ECE/TRANS/WP.29/GRSP/2009/21  
24 September 2009

GLOBAL TECHNICAL REGULATION No. 9  
(Pedestrian safety)

Phase 2 of the global technical regulation - flexible legform impactor

Proposal to develop amendments to global technical regulation No. 9 (pedestrian safety)

**Figure 13: Flex-PLI; Dimensions and C.G. locations of femur, knee joint, and tibia (Side view)**

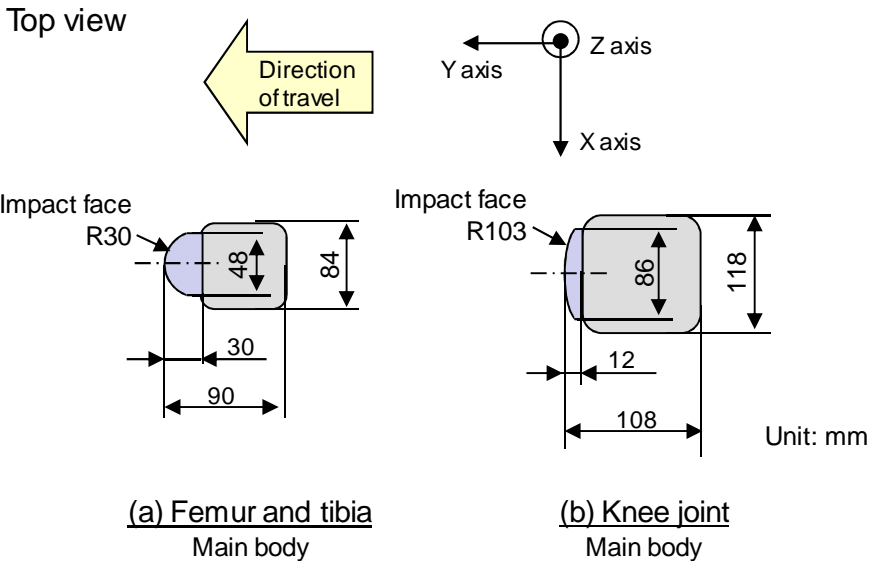
**The lower legform impactor shall consist of flesh, flexible long bone segments (representing femur and tibia), and a knee joint as shown in Figure 13.**

**The overall length of the impactor shall be  $928 \pm 3$  mm, having a required mass of  $[13.4] \pm 0.4$  kg including flesh. The length of the femur, knee joint, and tibia shall be  $339 \pm 2$  mm,  $185 \pm 1$  mm, and  $404 \pm 2$  mm respectively. The knee joint centre position shall be  $94 \pm 1$  mm from the top of the knee joint.**

Brackets, pulleys, protectors, connection parts etc. attached to the impactor for the purpose of launching and/or protecting may extend beyond the dimensions shown in Figure 13.

Figure 14: Flex-PLI; femur, tibia, and knee dimensions (Top view)

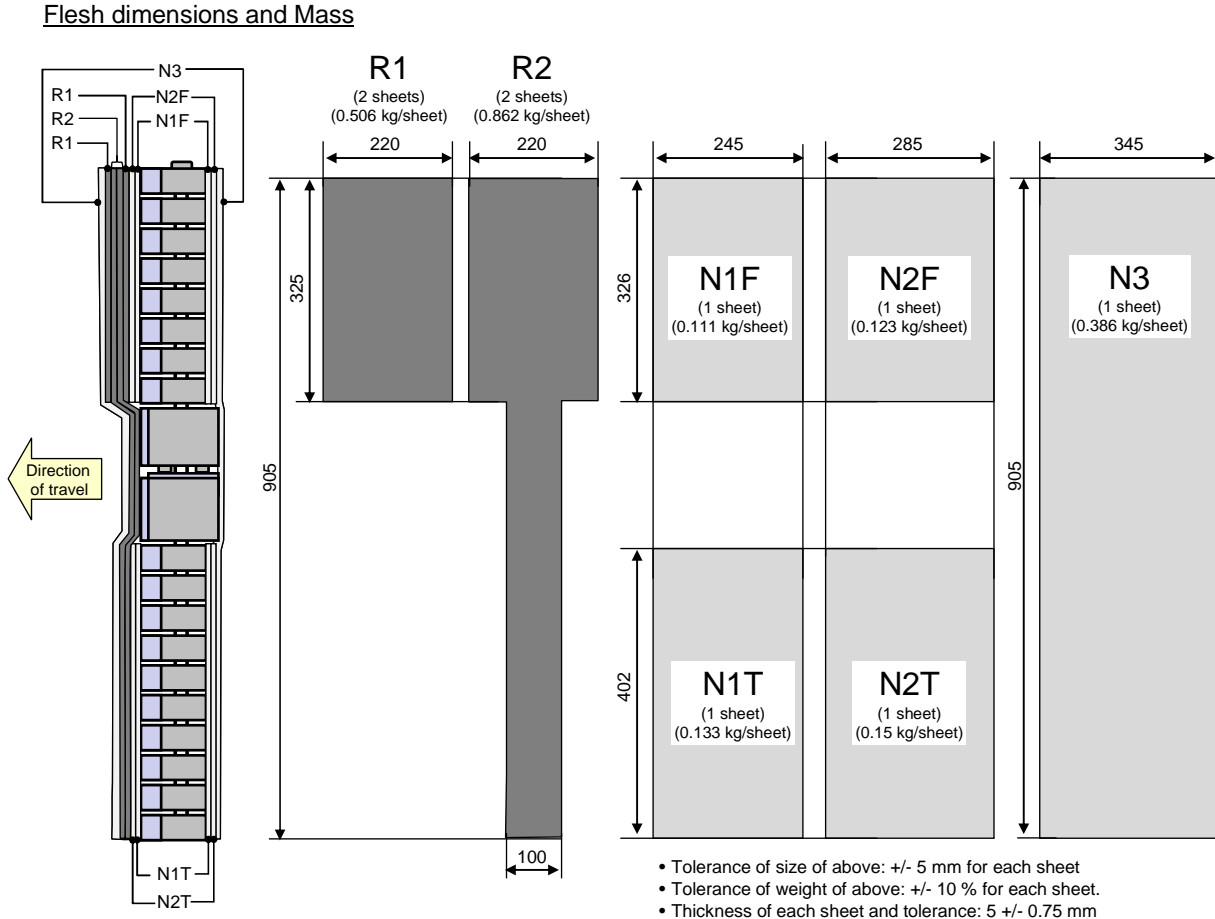
- 6.3.1.2.1. The cross-sectional shape perpendicular to the Z axis of the femur and tibia main bodies shall be  $90 \pm 2$  mm in width along the Y axis, and  $84 \pm 1$  mm in width along the X axis as shown in Figure 14 (a). The impact face shall be  $30 \pm 1$  mm in radius,  $30 \pm 1$  mm in width along the Y axis, and  $48 \pm 1$  mm in width along the X axis as shown in Figure 14 (a).

- 6.3.1.2.2. The cross-sectional shape perpendicular to the Z axis of the knee joint shall be  $108 \pm 2$  mm in width along the Y axis, and  $118 \pm 1$  mm in width along the X axis as shown in Figure 14 (b). The impact face shall be  $103 \pm 1$  mm in radius,  $12 \pm 1$  mm in width along the Y axis, and  $86 \pm 1$  mm in width along the X axis as shown in Figure 14 (b).

Figure 16: Flex-PLI; flesh compression characteristics

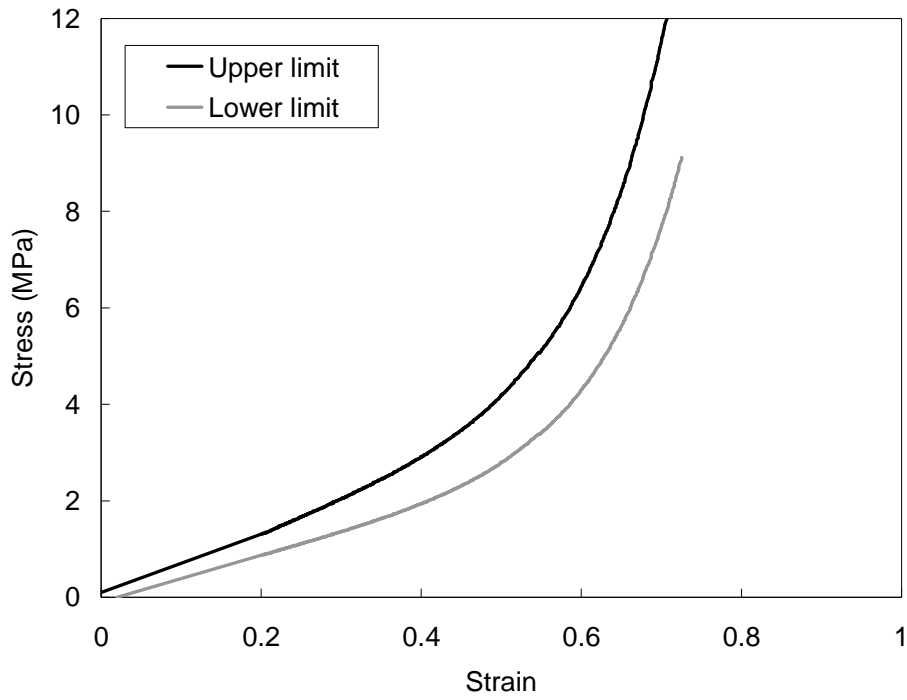
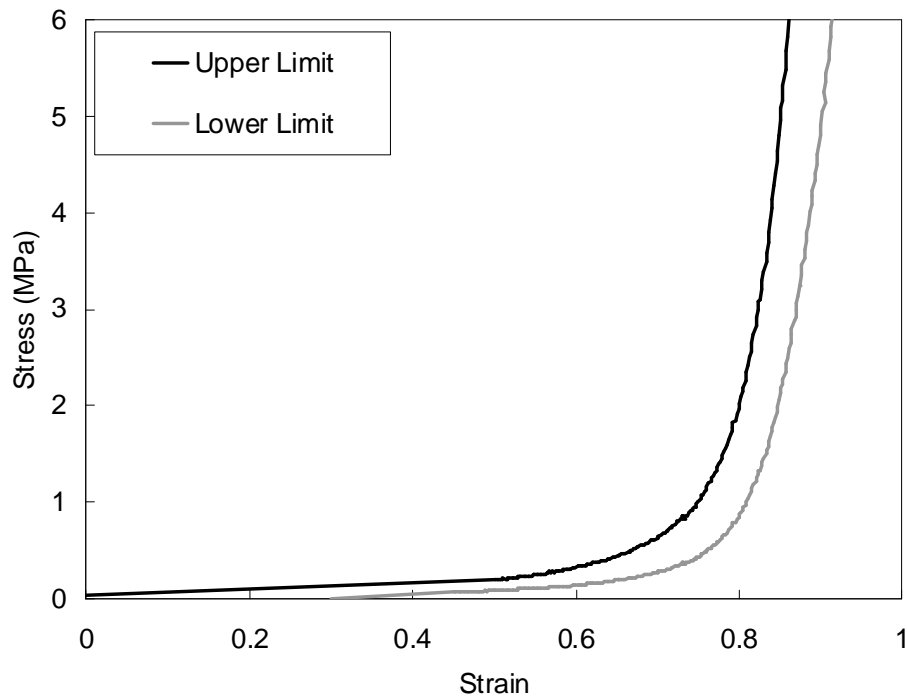
- 6.3.1.2.4. For each test, the impactor (femur, knee joint, and tibia) shall be covered by flesh composed of synthetic rubber sheets (R1, R2) and neoprene sheets (N1F, N2F, N1T, N2T, N3) as shown in Figure 15. The sheets are required to have a compression characteristic as shown in Figure 16. The compression characteristic shall be checked using the same batch of sheets as those used for the impactor flesh. The size and weight of the sheets shall be within the requirements described in Figure 16.
- 6.3.1.2.5. The test impactor or at least the flesh shall be stored for at least four hours in a controlled storage area with a stabilised temperature of  $20 \pm 4^{\circ}\text{C}$  prior to impactor removal for calibration. After removal from the storage, the

**Figure 17: Flex-PLI; instrument locations "**

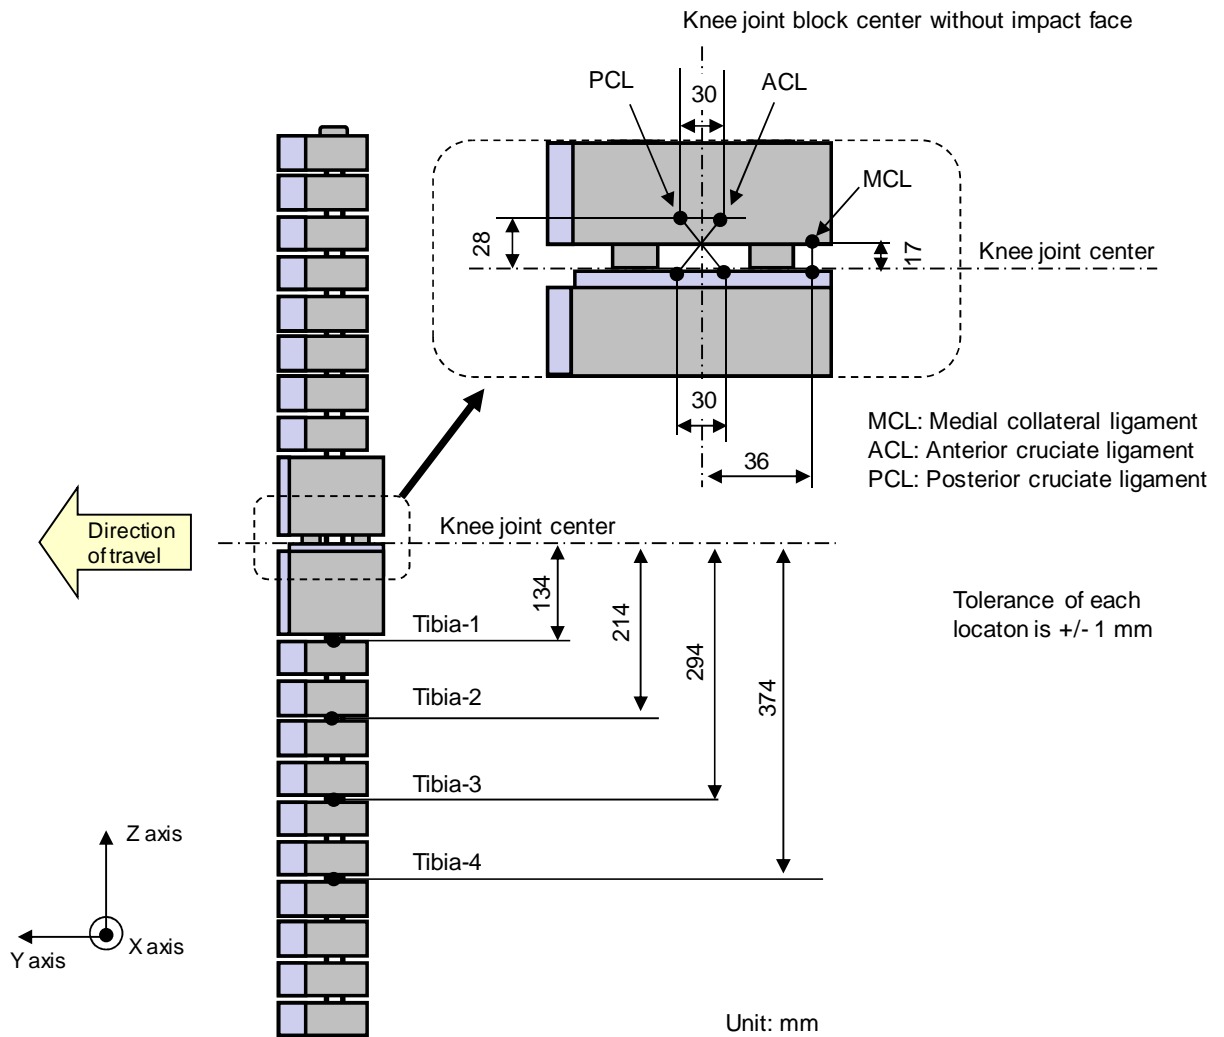
**6.3.1.2.6.1. Four transducers shall be installed in the tibia to measure bending moments applied to the tibia. The sensing locations of each of the transducers are as follows: tibia-1:  $134 \pm 1$  mm, tibia-2:  $214 \pm 1$  mm, tibia-3:  $294 \pm 1$  mm, and tibia-4:  $374 \pm 1$  mm below the knee joint centre respectively as shown in Figure 17. The measurement axis of each transducer shall be the X axis of the impactor.**

**6.3.1.2.6.2. Three transducers shall be installed in the knee joint to measure elongations of the medial collateral ligament (MCL), anterior cruciate ligament (ACL), and posterior cruciate ligament (PCL). The measurement locations of each transducer are shown in Figure 17. The measurement locations shall be within  $\pm 3$  mm along the X axis from the knee joint centre.**

**Figure 23: Tolerances of angles for the lower legform impactor at the time of the first impact (see paragraphs 7.1.2.2. and 7.1.2.3.2.)**

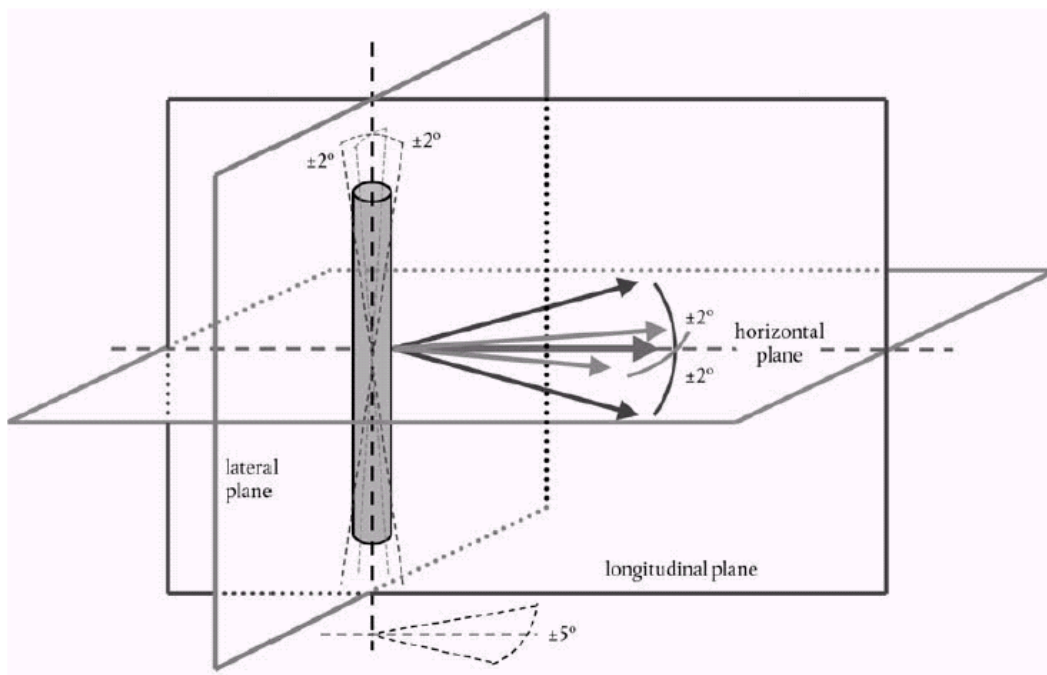
**7.1.2.2. The direction of the impact velocity vector shall be in the horizontal plane and parallel to the longitudinal vertical plane of the vehicle. The tolerance for the direction of the velocity vector in the horizontal plane and in the longitudinal plane shall be  $\pm [2]^\circ$  at the time of first contact. The axis of the impactor shall be perpendicular to the horizontal plane with a tolerance of  $\pm [2]^\circ$  in the lateral and longitudinal plane. The horizontal, longitudinal and lateral planes are orthogonal to each other (see Figure 23).**

**7.1.2.3.2. At the time of first contact the impactor shall have the intended orientation about its vertical axis, for the correct operation of its knee joint, with a tolerance of  $\pm 5^\circ$  (see Figure 23).**

**Figure 24: Flex-PLI to bumper tests for complete vehicle in normal ride attitude (left) and for cut-body mounted on supports (right) (see paragraph 7.1.2.3.) "**

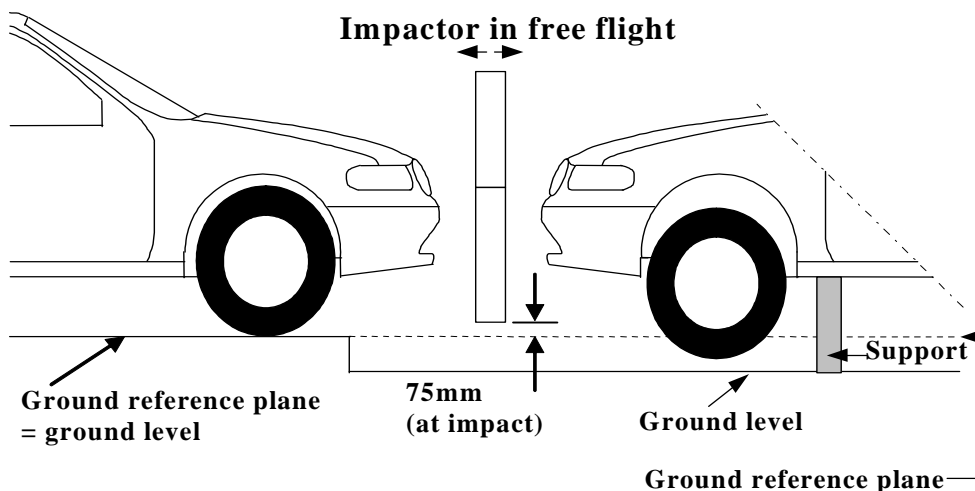
**7.1.2.3. The bottom of the impactor shall be at 75 mm above ground reference plane at the time of first contact with the bumper (see Figure 24), with a  $\pm [10]$  mm tolerance. When setting the height of the propulsion system, an allowance must be made for the influence of gravity during the period of free flight of the impactor.**

Figure 31: Requirement corridor of femur and tibia in static certification test (see paragraph 8.2.1.2.)

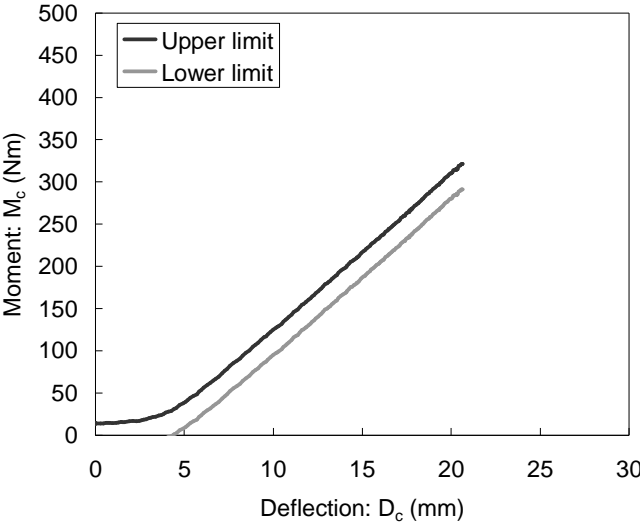
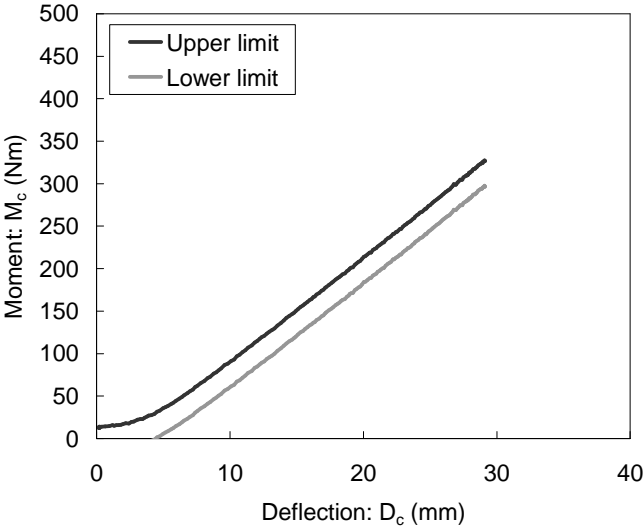
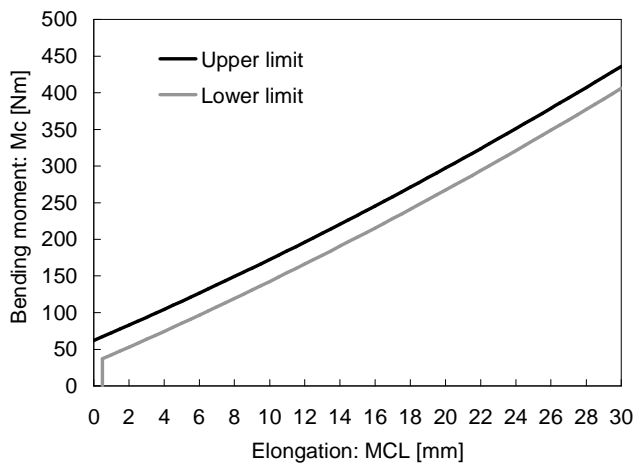
**8.2.1.2. When the femur and tibia of the impactor are loaded in bending in accordance with paragraph 8.2.1.4., the applied moment and generated deflection at the centre of the femur and tibia ( $M_c$  and  $D_c$ ) shall be within the corridors shown in Figure 31.**

**Figure 32: Requirement corridors for knee joint in static certification test (see paragraph 8.2.1.3.)**

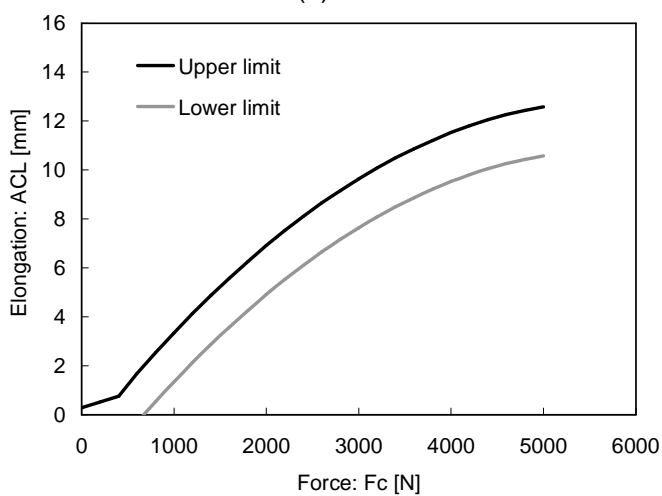
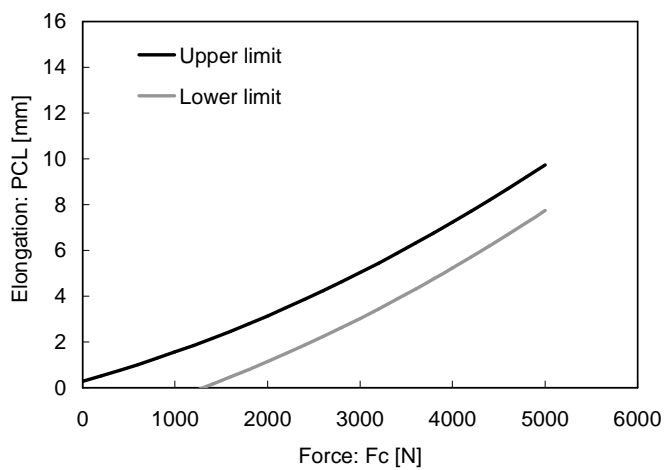
**8.2.1.3. When the knee joint of the impactor is loaded in bending in accordance with paragraph 8.2.1.5., the MCL, ACL, and PCL elongations and applied bending moment or force at the centre of the knee joint ( $M_c$  or  $F_c$ ) shall be within the corridors shown in Figure 32.**

**Figure 33: Test set-up for femur in static certification tests**  
 (see paragraph 8.2.1.4.)

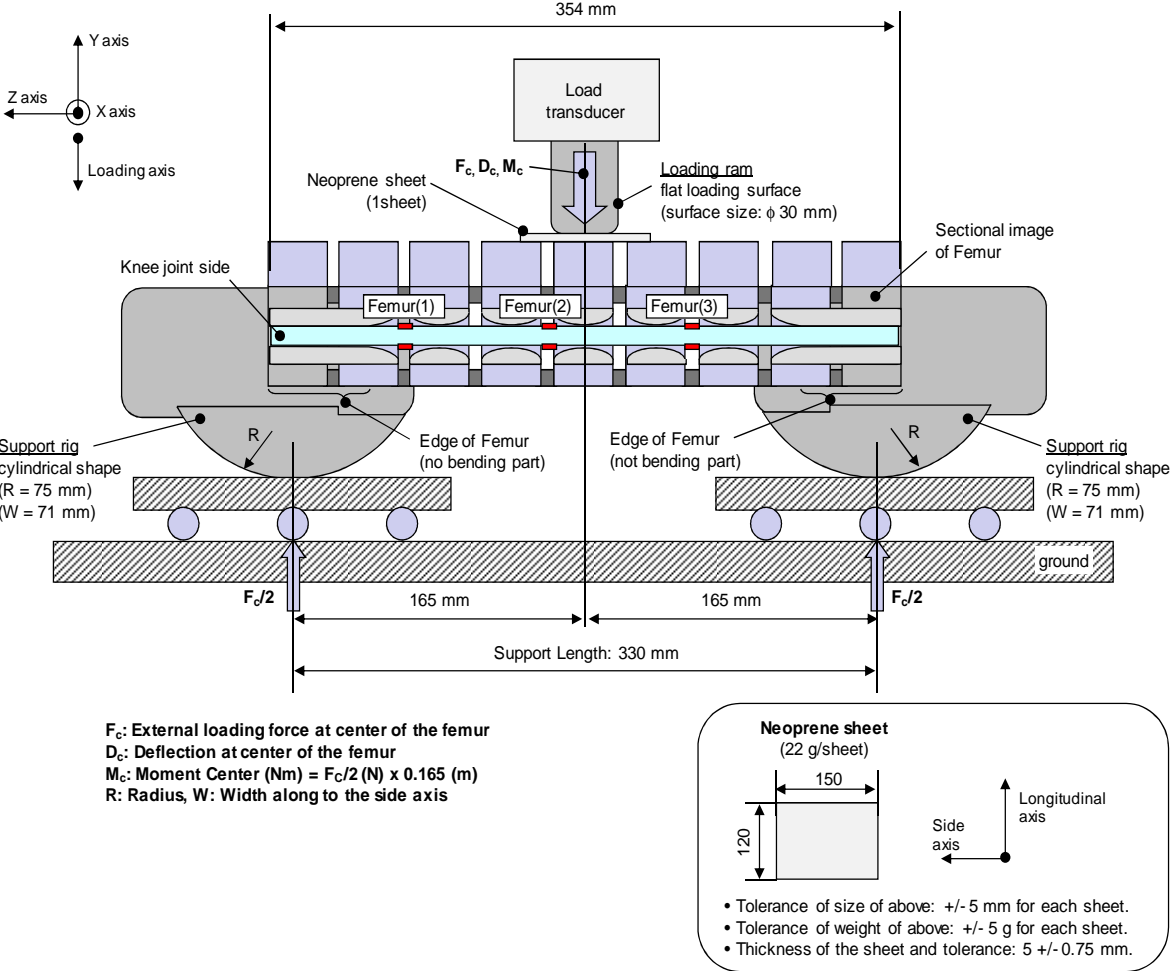
**8.2.1.4.** The edges of the femur and tibia, not bending parts, shall be mounted to the support rig firmly as shown in Figure 33. The Y axis of the impactor shall be parallel to the loading axis within  $180 \pm 2^\circ$  tolerance. In order to avoid friction errors, roller plates shall be set underneath the support rigs. To avoid impactor damage, a neoprene sheet shall be set underneath the loading ram. The neoprene sheet used in this test shall have compression characteristics as shown in Figure 16.

**Figure 34: Test set-up for tibia in static certification tests**  
(see paragraph 8.2.1.4.)

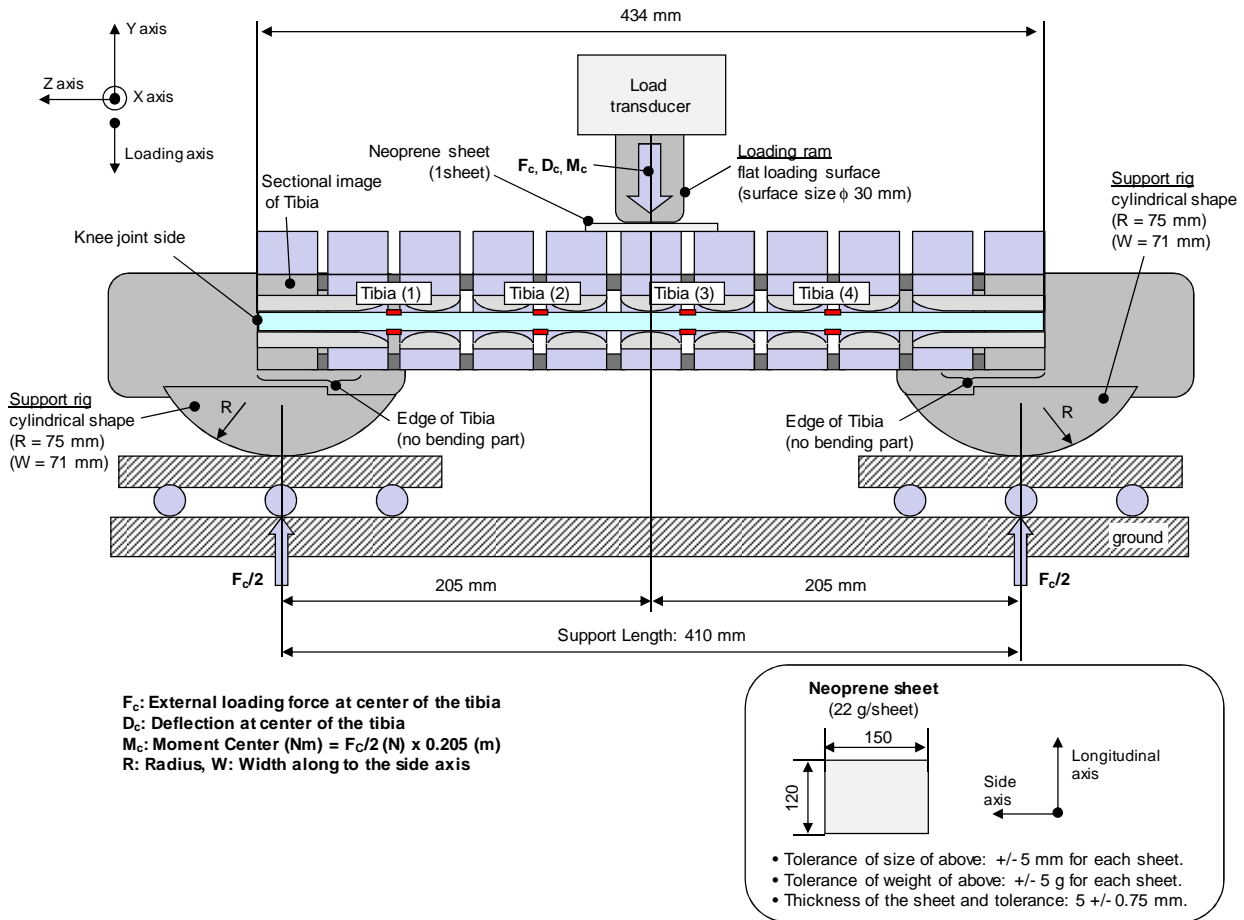
The centre of the loading force shall be applied at the centre of the femur and tibia within  $\pm 2^\circ$  tolerance along the Z axis. The force shall be increased at a rate between 10 and 100 mm/minute until the bending moment at the centre part ( $M_c$ ) of the femur or tibia reaches [340] Nm.
